nical Customer Service Automatic models VKT 10 du/wi-bal

München, April 1969 No. 2/69 (517) en.

RE: Adjustment of the throttle linkage

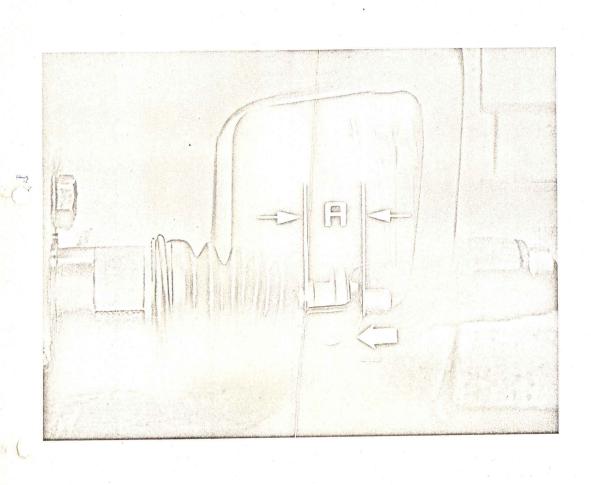
Push the release lever by hand into driving direction till the stop of the clutch slave cylinder. In new condition the measured travel on the push rod Aamounts to 17 to 19 mm, see figure. As the wear of the clutch disc increases, the distance A decreases and when it reaches a minimum of A = 5 mm the clutch disc is to be replaced.

Bild 1

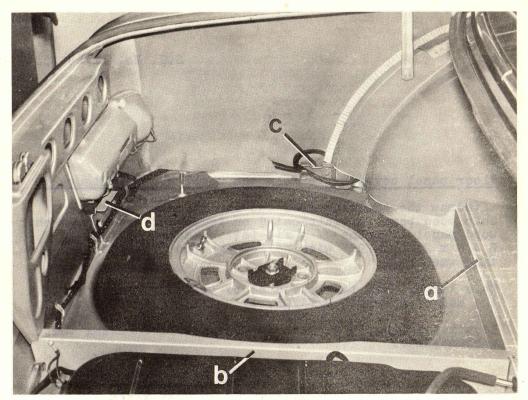
BMW 20006/CA/CS, 280003 Group: Body & Fittings Support points (figures 1 and 2)

- a) Crossmember between the wheelhouses, on the entire length.
- b) Brace plate middle of luggage compartment floor -, on the entire length.

c) Support plates on the wheel houses, right and left.

d) Reinforcement plates, right and left, for the mounting of bumper brackets.

Bild 3

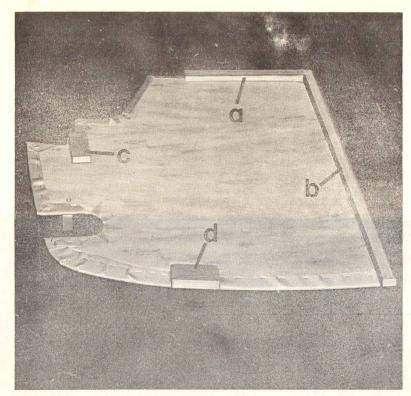
Spacer strip on covering panel, luggage compartment floor, at the right (figure 3)

In conformity with the above mentioned support scheme the spacer strips are simply placed beneath and secured by means of the floor covering mounting screws.

Wooden strips: 19 mm x 25 mm, length according to the support sides b, c and d.

6 fillister head counter-sunk metal screws B 4.8 x 32 DIN 7983 with hollow washer (cloth protecting washer) support a - 2 screws, b - 2 screws and c. d each 1 screw.

Bild 4

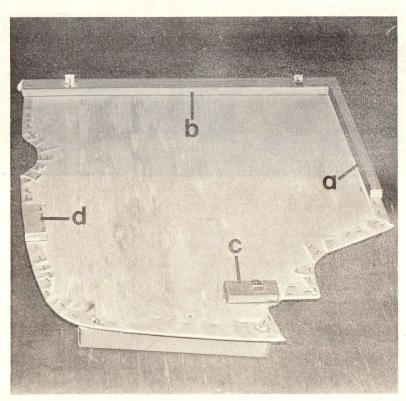
Spacer strips on covering panel, luggage compartment floor, at the left (figure 4)

Contrary to the right side covering the spacer strips should be screwed firmly to the covering panel, after having removed the clamping springs and their retaining screws.

Wooden strips: 19 mm x 45 mm, length according to the support sides b, c and d.

13 fillister head countersunk wood screws 5 x 20 DIN 7995 with hollow washer (cloth protecting washer)

Support a -4 screws Support b - 5 screws Support c -2 screws Support d - 2 screws

The clamping springs are now reinstalled on to the spacer strips in accordance with their original position, by means of round head wood screws 5 x 20 DIN 7996.

Bild 5

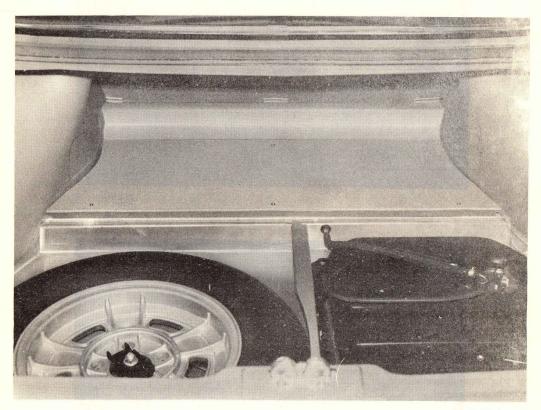
Floor panel covering between the wheel houses (figure 5)

Withdraw the covering foil and install a 16 mm thick chip wood panel prefabricated on template. Secure the chip wood panel by means of 4 fillister head metal screws B 4.8 x 25 DIN 7983 with hollow washers (cloth protecting washers).
